# ECP 2.1 Constraints Forecast Report

## **FAQ Document**

16<sup>th</sup> March 2022

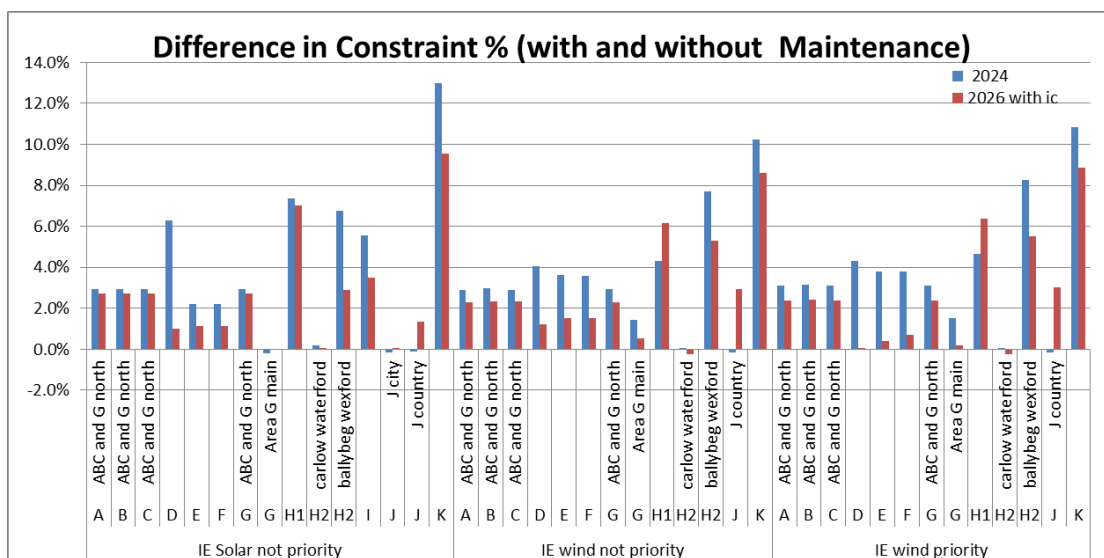
**Q: Can EirGrid undertake a sensitivity analysis of one of the scenarios, where the maintenance outages are removed?**

A: The below graph shows area and subgroup results (% constraints difference) by comparing two studies one with maintenance and a second study without maintenance. The analysis was carried out for 2 study scenarios: “2024 ECP (All)” and “2026 with Greenlink ECP (All)”. Greater detail on this topic is available in the Report Addendum on the EirGrid website<sup>2</sup>.
